Year 7 Monitoring Report

Hudson Property

DMS Project ID #: 95361
DMS Contract #: 004638
DWR Project #: 20140422
USACE Action ID# SAW-2012-01394

RE: Draft Year 7 Monitoring Report for Hudson Property – (DMS#: 95361) (Ecotone #1269)

Figure 5: Monitoring Well 3 – Reach 4

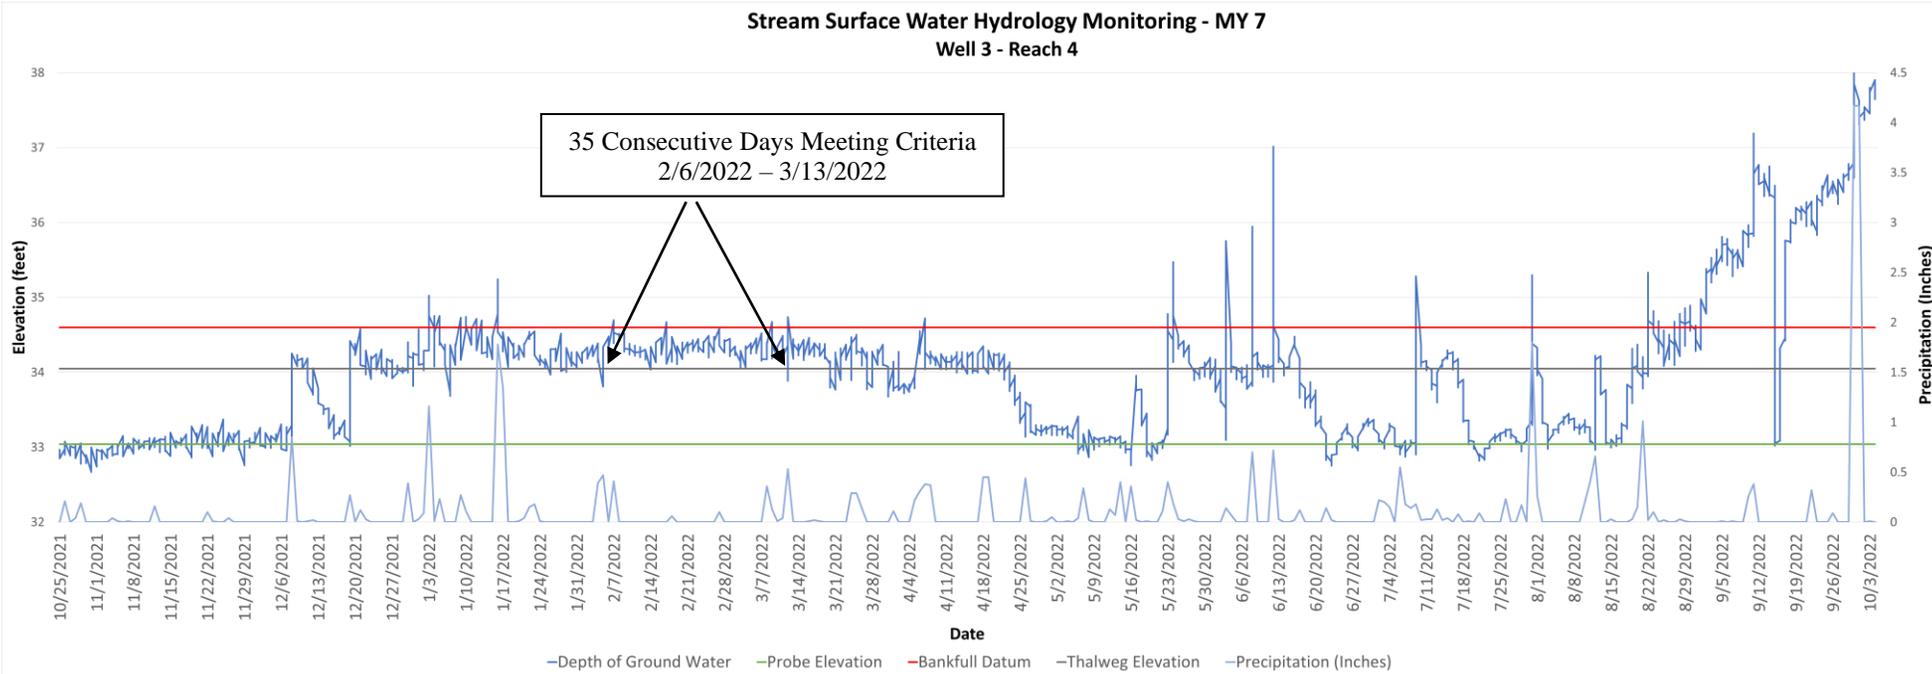
7. *Some flow gauges show hydrology that dipped below the thalweg and yet was counted toward consecutive days of flow (Figure 5 for example). Recommend recalculating consecutive days of flow for MY7, and all prior years if possible, and updating Table 13 accordingly. Please remove footnotes that say “Ground water line may drop below thalweg...”*
Ecotone Response: Consecutive days meeting flow was recounted for monitoring year 7 and adjusted on the graphs, as well as in Table 13.

Comment Revisited 1/6/2023: Consecutive days meeting flow was also recalculated for all 10 wells from monitoring years 1-6. All the changes listed above can be seen in the updated Table 13.
